ADDENDUM 1

CSP 23-27

GYMNASIUM ADDITIONS/IMPROVEMENTS FOR CAVAZOS & TREVINO ELEMENTARY SCHOOLS

ADDENDUM NO: ONE (1)

2 WALL SECTION DETAIL - TRANSITION NEW TO EXISTING
1/2" = 1'-0"

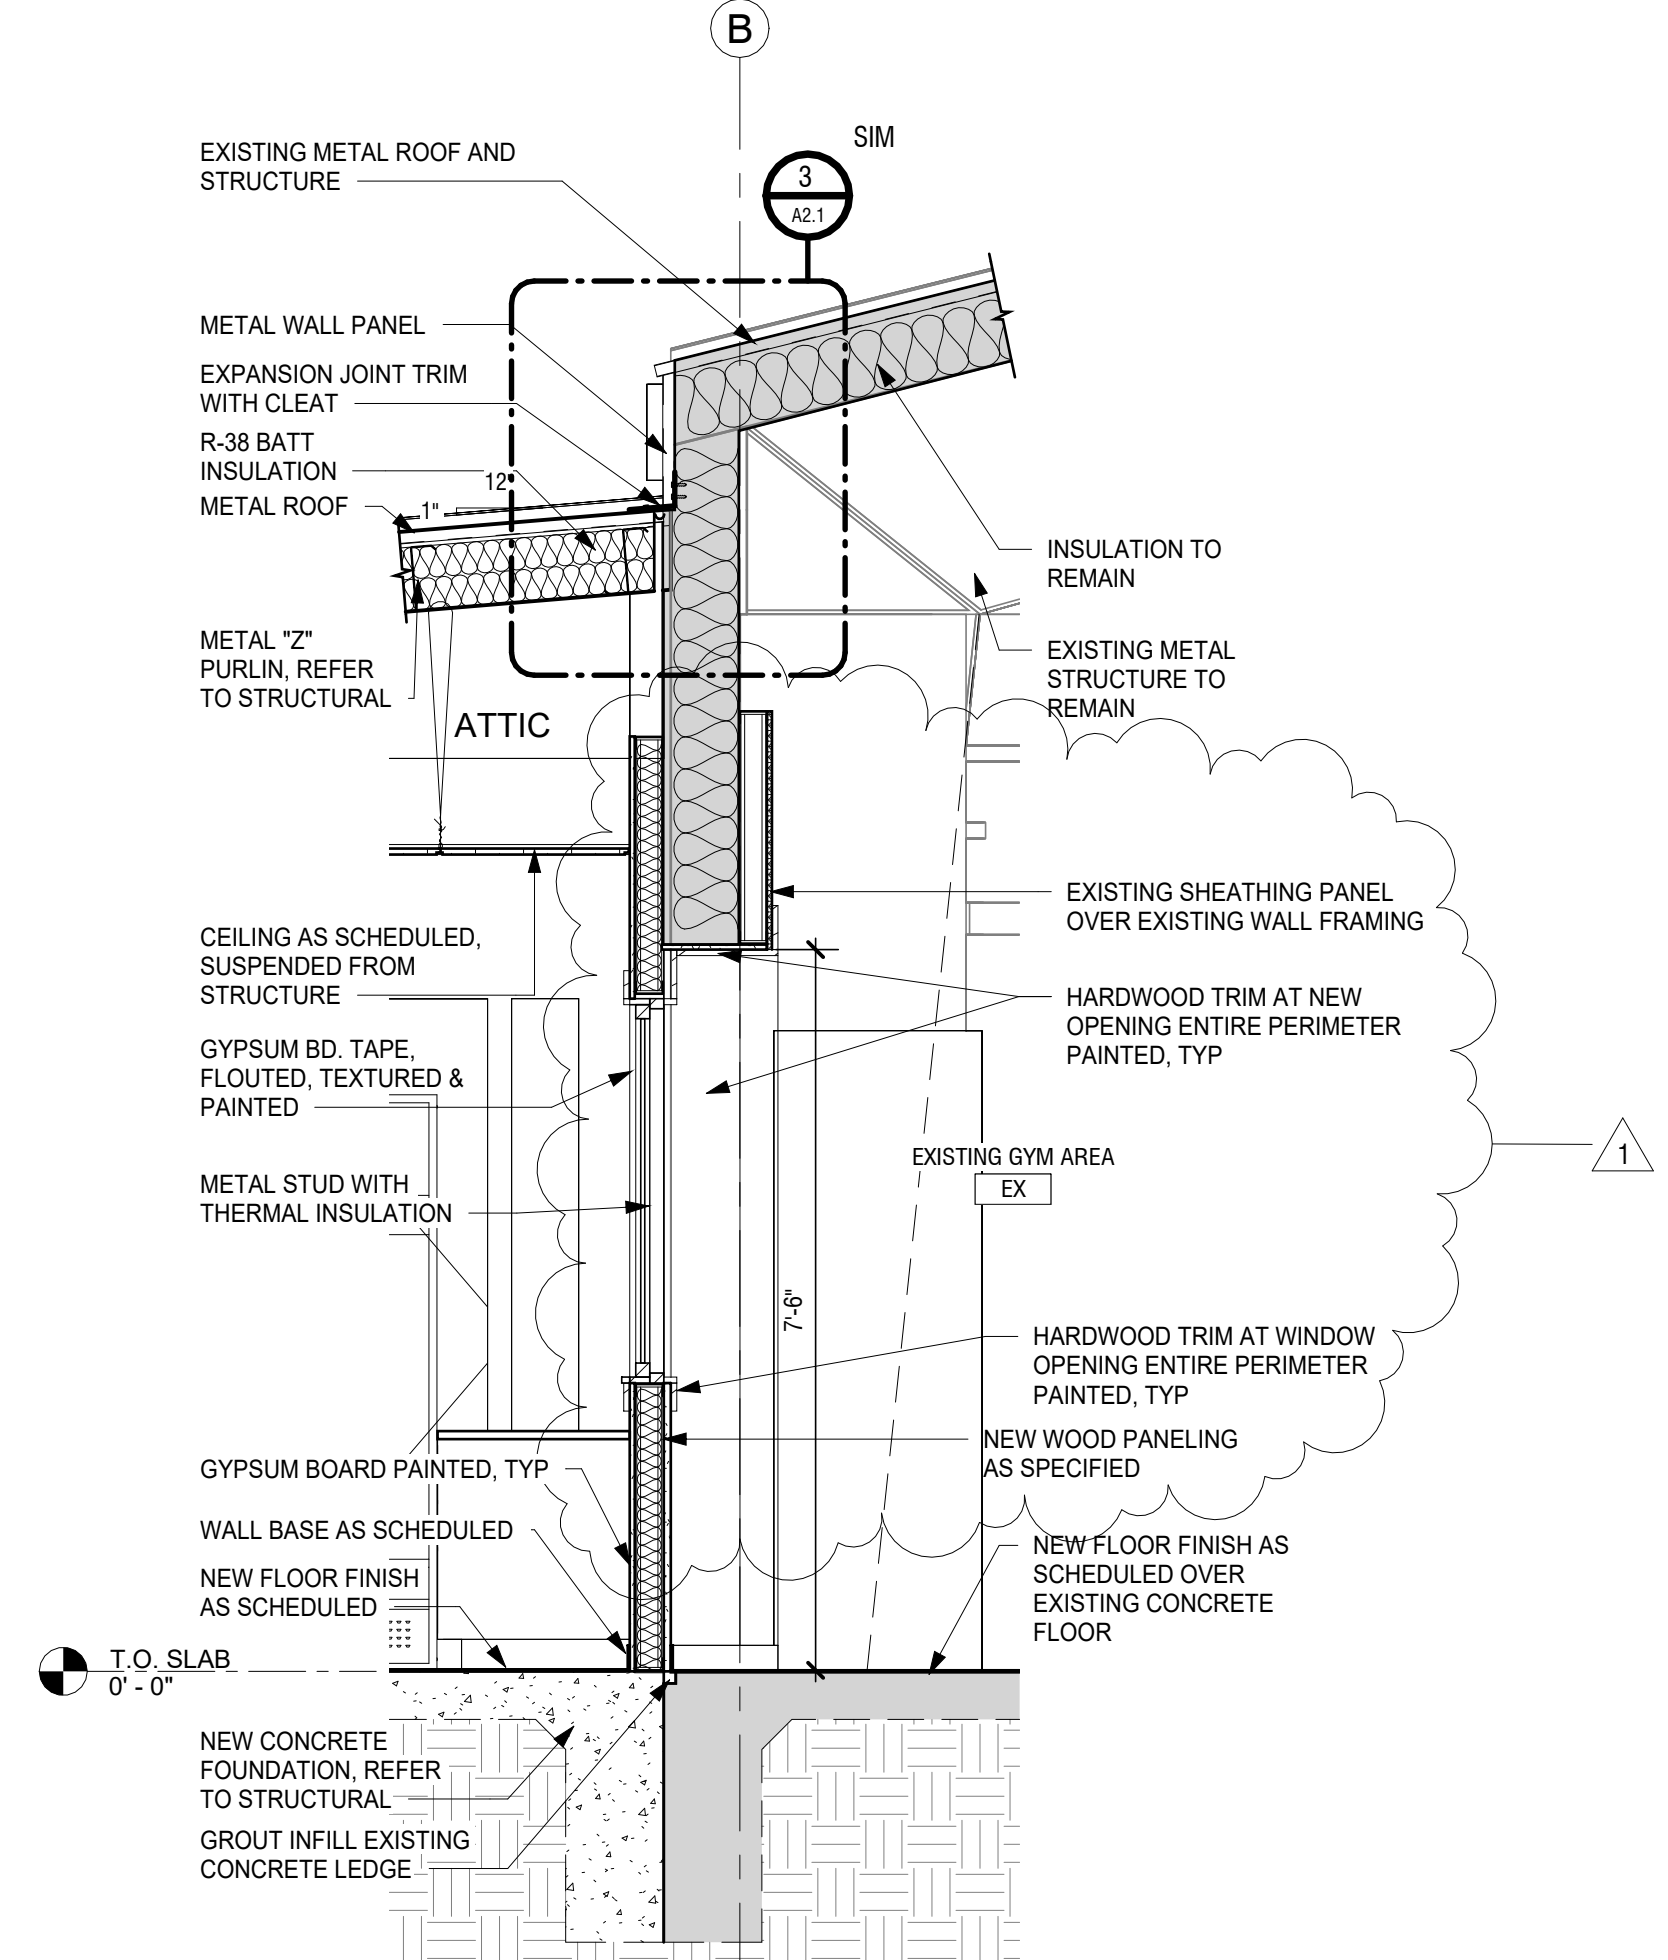
4. SHEET A4.2 WALL SECTIONS AND DETAILS (INCLUDED HEREWITH)
 - a. At wall section 2/A4.2 delete note "REPLACE EXISTING SHEATHING PANEL OVER EXISTING WALL FRAMING REPLACE WITH NEW SHEATHING PANEL REFER TO SPECS" and replace with note "EXISTING SHEATHING PANEL OVER EXISTING WALL FRAMING"

4 WALL SECTION DETAIL - WINDOW
1/2" = 1'-0"

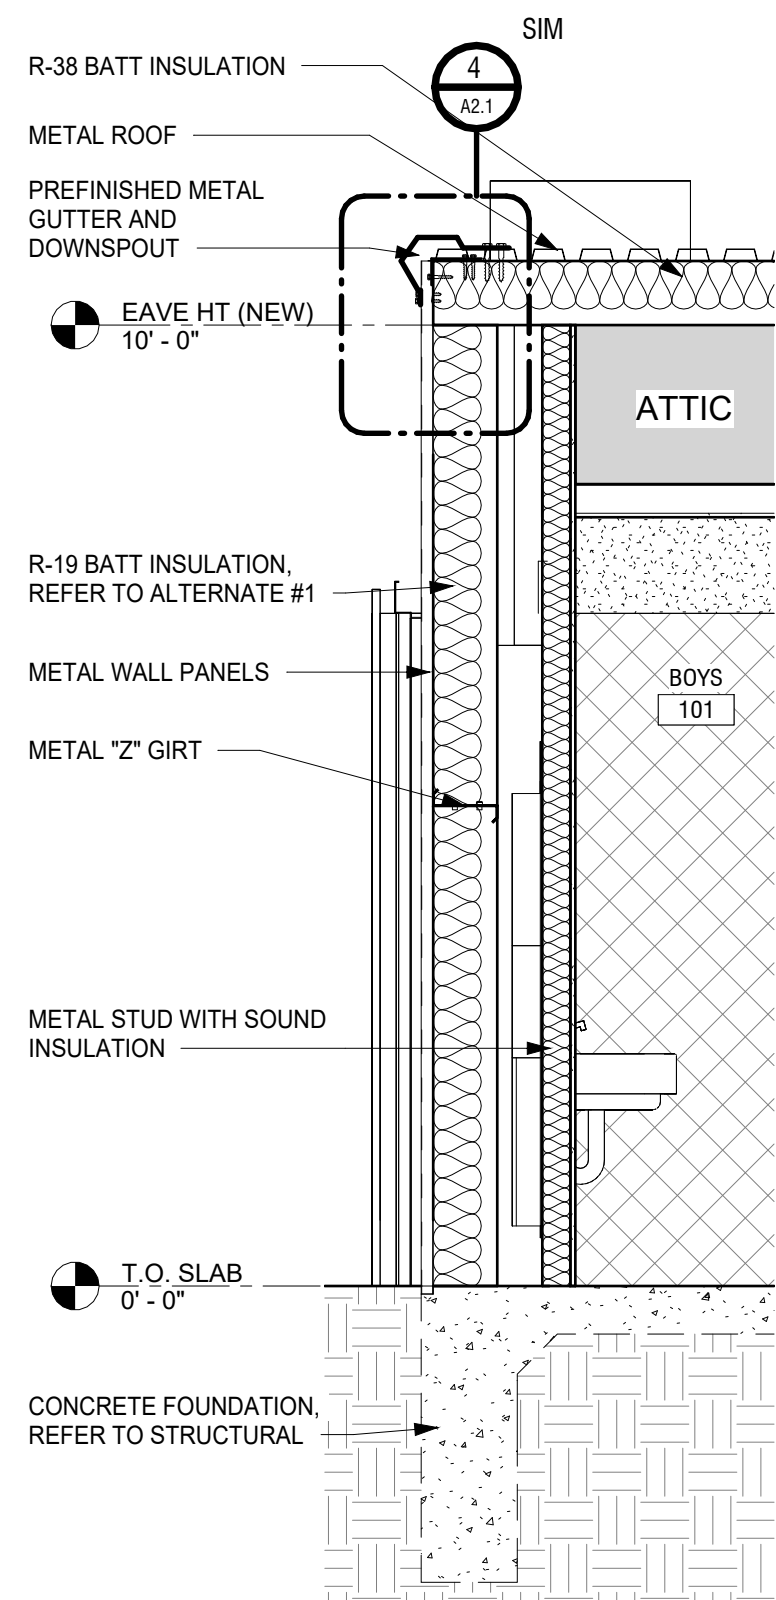
- b. At wall section 4/A4.2 modify wall section as shown and update notes as shown
5. SHEET A5.2 INTERIOR ELEVATIONS (INCLUDED HEREWITH)
 - a. Delete entire sheet A5.2 and replace with sheet A5.2 included herewith
